# SERVICE INFORMATION

# LAND-ROVER PETROL AND DIESEL MODELS

Rover  
British Leyland UK Limited,  
Solihull, Warwickshire, England

### INDEX Vol. 1 No. 13

**Fig. 1 Identification of cylinder block plugs**

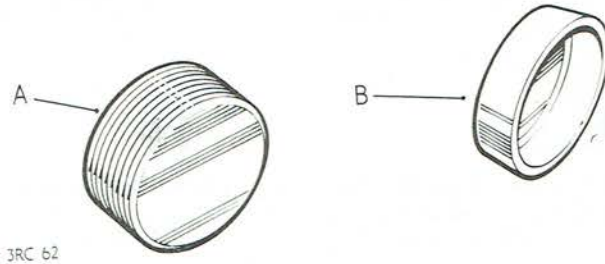
**MODIFICATION:** Introduction of cup plugs to replace core plugs.

Cup plugs are now fitted in place of the threaded core plugs from the above engine serial numbers onwards.  
Both plugs will be stocked by our Parts Department at Cardiff as they are not interchangeable.

**Fig. 2 Application of Foliac anti-seize compound to exhaust manifold**  
A—Apply compound moderately to these areas

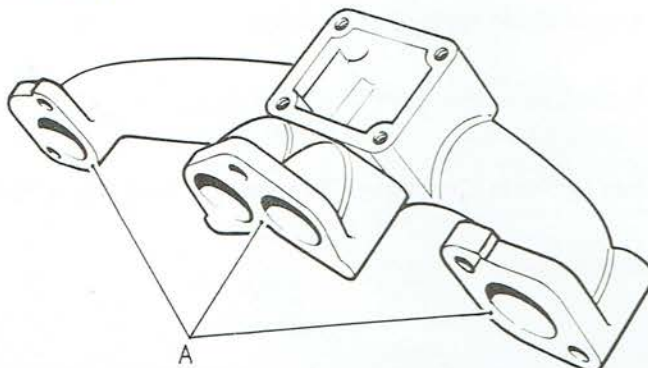
Introduction of anti-seize compound to reduce tendency for the exhaust manifold to crack.

To reduce the tendency for exhaust manifolds to fracture in service, the cylinder head engaging surfaces of the manifold should be moderately coated with 'Foliac' anti-seize compound. Care must be taken to ensure that the manifold faces are clean and flat and the coating of the compound is applied just prior to fitting the assembly to the cylinder head. The manifold fixings should then be tightened to 1,3 kgfm (10 lbf ft).

**Fig. 3 Gear lever ball end**

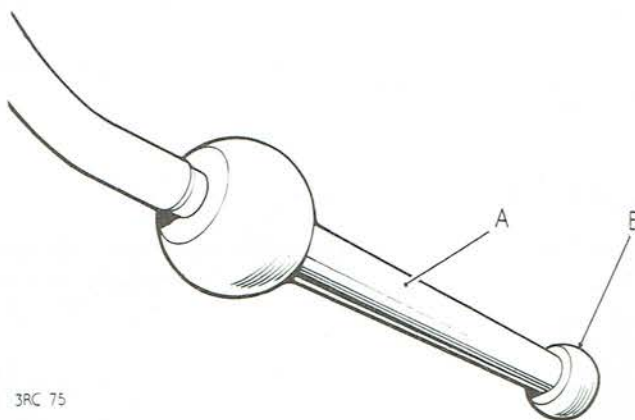
**MODIFICATION:** Introduction of finalised details in respect of gear lever ball end originally introduced in Service Information Vol. 1, No. 7, item 23.

**REMARKS:** A few isolated failures have occurred since the introduction of the revised material specification. These failures were experienced in one batch only which was subsequently found to be to an incorrect material specification.  
 This situation has now been rectified and all supplies from the above gearbox serial numbers are to the correct specifications.  
 Any failures of gear lever ball ends on gearboxes after the above numbers should be reported immediately to the Technical Service Department, using the appropriate Product Defect Report Form: UK Part No. AKD 8002, Export Part No. AKD 5181.

**Fig. 4 Rear cross member location**

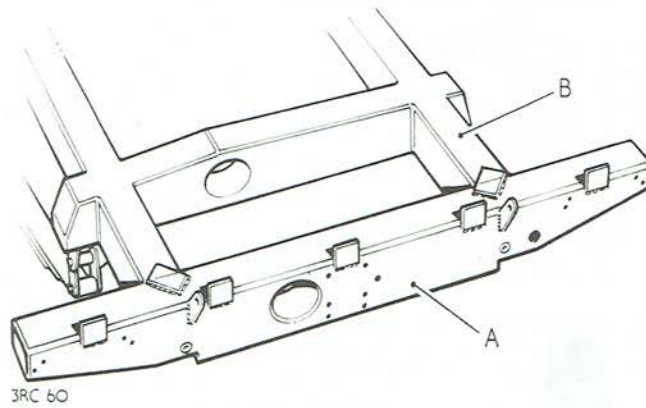
**MODIFICATION:** Introduction of rear cross member as a separate item to avoid the need of a complete chassis frame to be fitted where the damage is restricted to the rear cross member.

Owing to its location and the subsequent danger of exposure to corrosion and susceptibility to rear collision damage the rear cross member on the chassis frame is now available from our Parts Department at Cardiff as a separate item under the above part number.

Although the replacement of the rear chassis cross member can be effected without the use of a jig, the rear body must be removed as detailed in the appropriate Workshop or Repair Operation Manual.
